STAFF RECOMMENDATION

1913 Shelby Avenue

February 17, 2021

Application: New Construction--Addition

Figure 2 (left) shows the window changes on the right façade and Figure 3 (right) shows the window changes on the left façade.

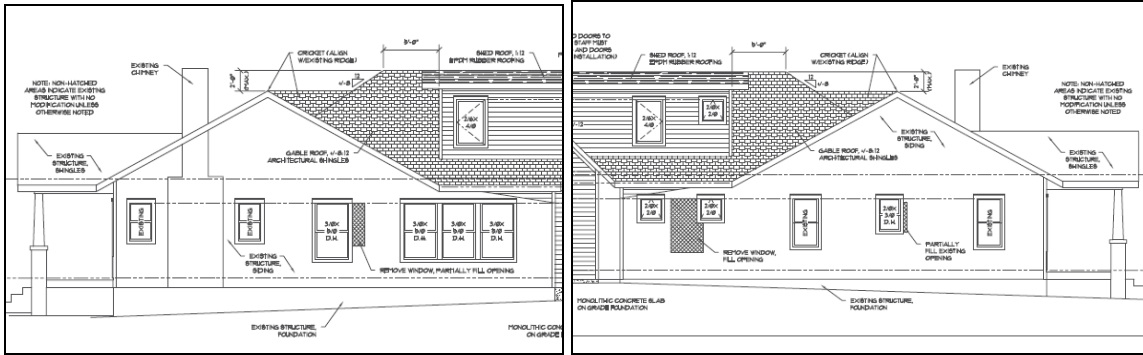
Partial Demolition: The applicant proposes to alter window openings, which is considered partial demolition. On the left façade, the applicant proposes to change the size of an opening in the back half of the house (Figure 2). Since there will still be an opening in this location and it is located towards the back of the house, staff finds this partial demolition to meet the design guidelines. Similarly, on the left side, the applicant is altering the size of a window opening at the midpoint, and is replacing a window opening at the back with two, smaller square window openings (Figure 3). Staff finds the changes on the left side to meet the design guidelines for appropriate demolition because the window at the midpoint is only slightly changing, and the window at the rear is on part of the house that the 1957 Sanborn map shows as being a porch at that time (Figure 4).

Staff finds that the proposed window opening alterations to meet Section III.B.2 of the design guidelines for appropriate demolition.
